Office Action Summary

10/821,860

CABRELE, FEDERICO

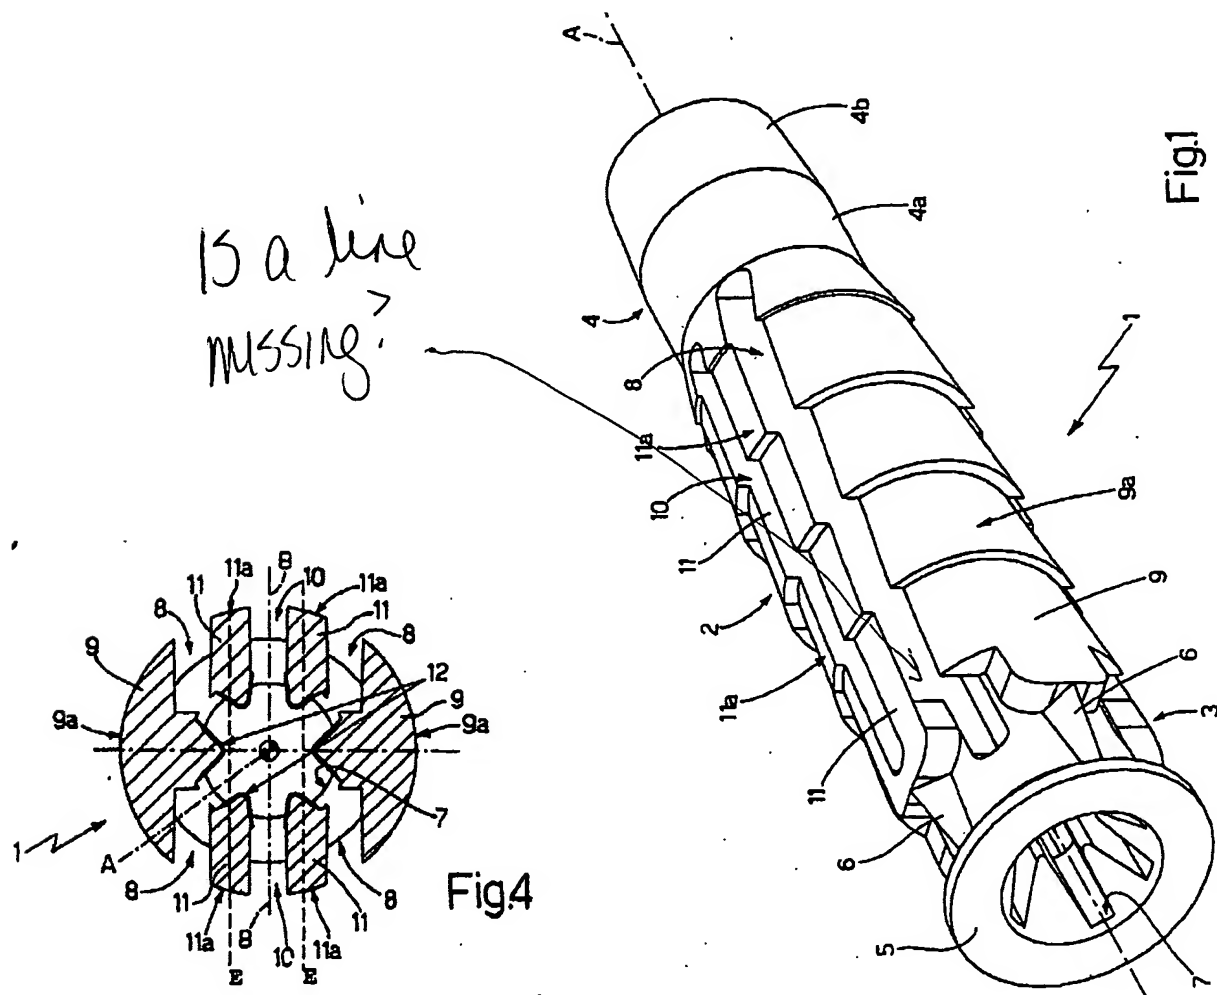
1. The drawings are objected to because examiner does not see how Fig 1 corresponds with Fig 4. Note that Fig 4, for example, clearly shows that secondary tongue 11 has a "thickness" or "depth" (material dimension from outer circumference toward axis A), but this is not clear in Fig 1 -- perhaps a line is missing.

Also, In Fig 1 above, "11" is used to point to both a secondary tongue and a slot?

Corrected drawing sheets in compliance with 37 CFR 1.121(d) are required in reply to the Office action to avoid abandonment of the application. Any amended replacement drawing sheet should include all of the figures appearing on the immediate prior version of the sheet, even if only one figure is being amended. The figure or figure number of an amended drawing should not be labeled as "amended." If a drawing figure is to be canceled, the appropriate figure must be removed from the replacement sheet, and where necessary, the remaining figures must be renumbered and appropriate changes made to the brief description of the several views of the drawings for consistency. Additional replacement sheets may be necessary to show the renumbering of the remaining figures. Each drawing sheet submitted after the filing date of an application must be labeled in the top margin as either "Replacement Sheet" or "New Sheet" pursuant to 37 CFR 1.121(d). If the changes are not accepted by the examiner, the applicant will be notified and informed of any required corrective action in the next Office action. The objection to the drawings will not be held in abeyance.

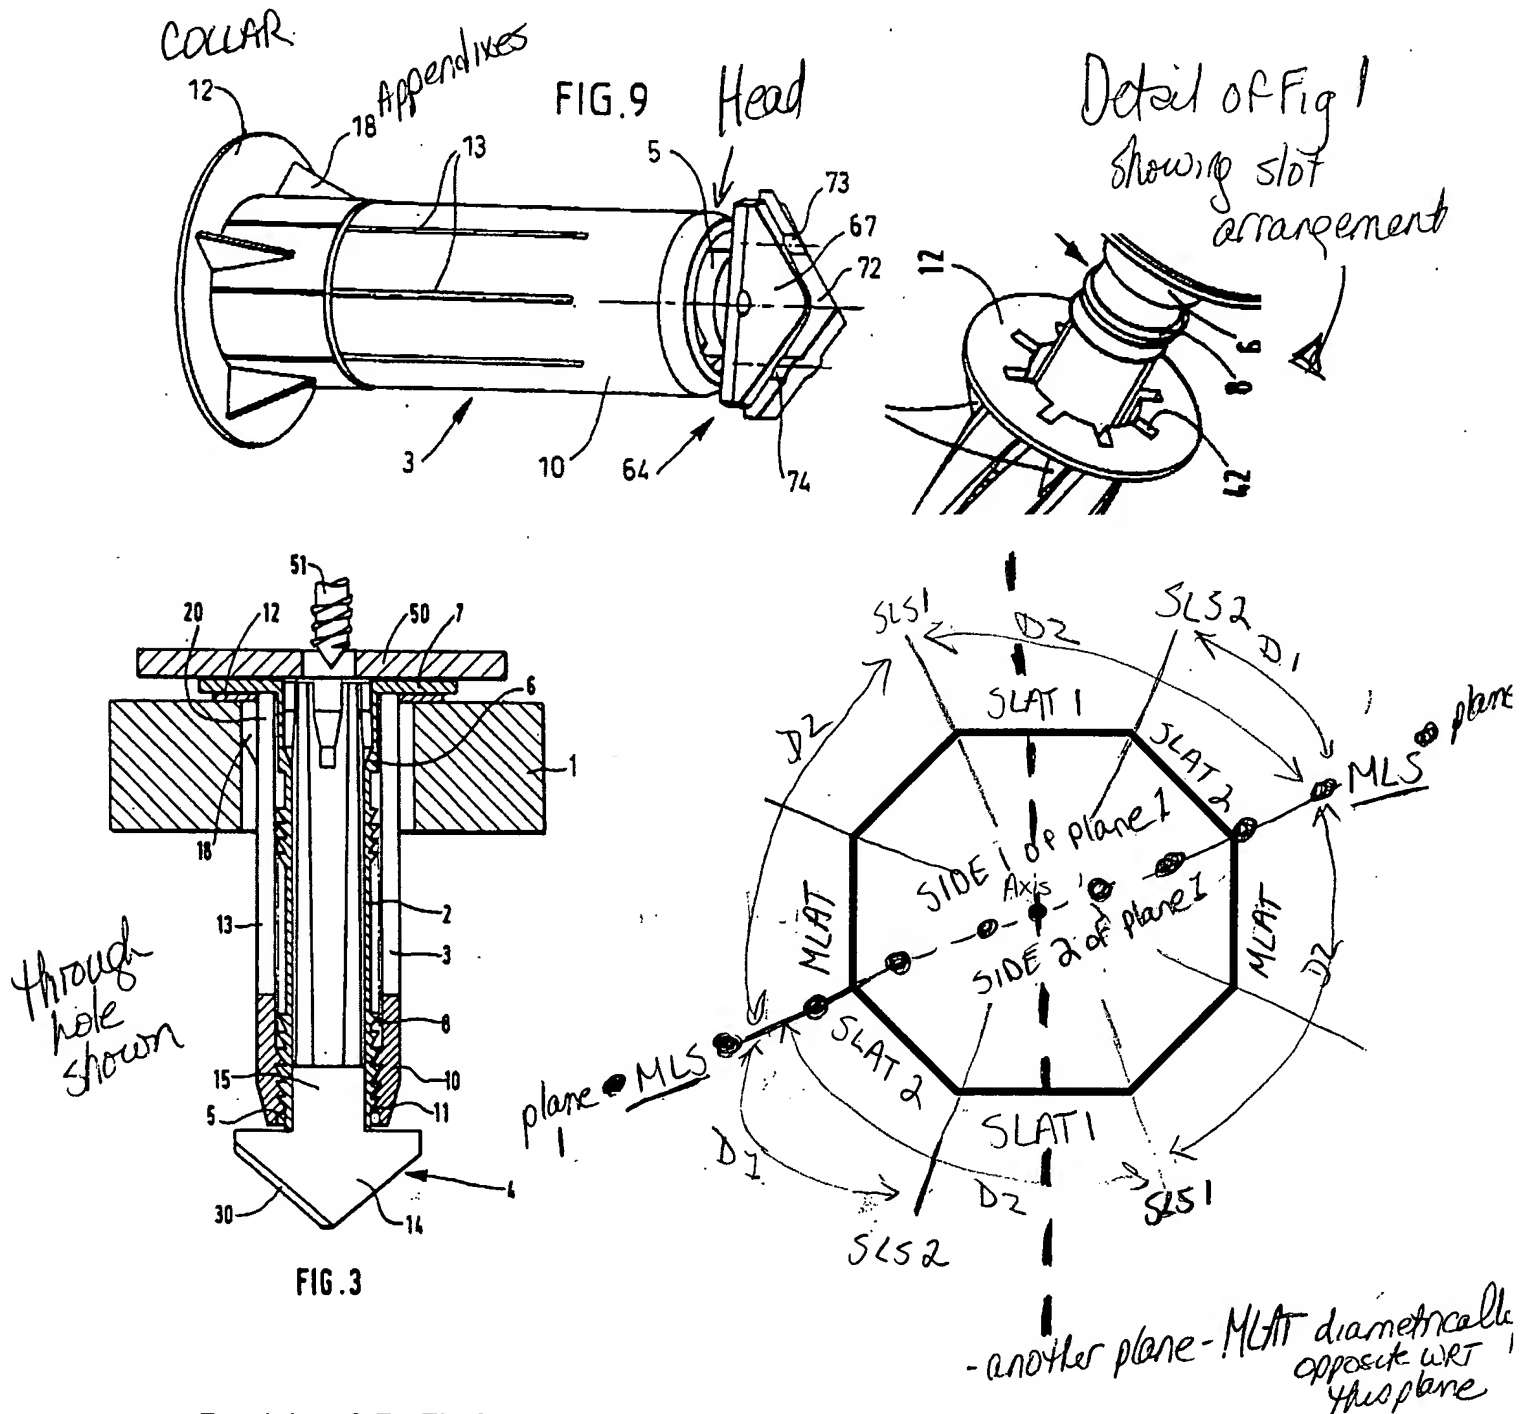
Re claims 1, 14: Vernet shows a screw anchor (3) with a deformable (expandable -abstract) central portion in which main longitudinal slots (MLS) (4 of the slots labeled "13") are formed, and further comprising secondary longitudinal slots (SLS) (the remaining 4 of the slots labeled "13") formed in said central portion. Examiner notes that 4 of the slots (13) are considered main (MLS) and the balance are considered secondary (SLS). The main longitudinal slots MLS extend essentially parallel to a plane on which a longitudinal axis of the screw anchor lies, and define deformable main longitudinal anchoring tongues (MLAT) which lie on opposite sides of the plane. Currently the embodiment of Fig 9 is being applied since it is clearer. However, note col 3 line 66 - col 4 line 2, which explicitly states that the slots 13 are in planes which may be inclined with respect to the axis OR which pass through the axis as in Fig 3. However, Fig 9 shows this most clearly, and note that col 5 lines 12-18 specifies that the only difference in the first and 2nd embodiments is the piercing means of the pin body -- the sleeve {anchor} are the same.

Re claim 3: Pairs of main longitudinal slots (MLS) define main longitudinal anchoring tongues (MLAT) (strip between two "13's". There are 8 equally-spaced slots "13"

from (see detail of Fig 1 below)

from Fig 1 below) - examiner has labeled an octagon below, with each corner representing a slot, with which slots are considered main and which are considered secondary.

Re claims 8-9: As best understood, referring to the numbering by examiner of the octagonal shape, representing the collar with 8 slots of Vernet, there are 4 SLS arranged in 2 pairs that are arranged in mirror image relationship with each other, and the SLS of each pair are parallel. Since examiner does not know of that there are "the slots of each pair" {implying at least 4??}, examiner is not sure what is being described. However, note equivalent Distances D1 and D2 on octagonal drawing, with each slot of pair SLS1 having equal distances from MLS as each slot of pair SLS2.

Further re claim 14: Deformable main longitudinal anchoring tongues (MLAT) are arranged diametrically opposite one another with respect to the longitudinal axis of the anchor, and secondary longitudinal anchoring tongues (SLAT) are arranged in essentially mirror image pairs in which each pair is arranged diametrically opposite the longitudinal axis. (see marked up drawing above)
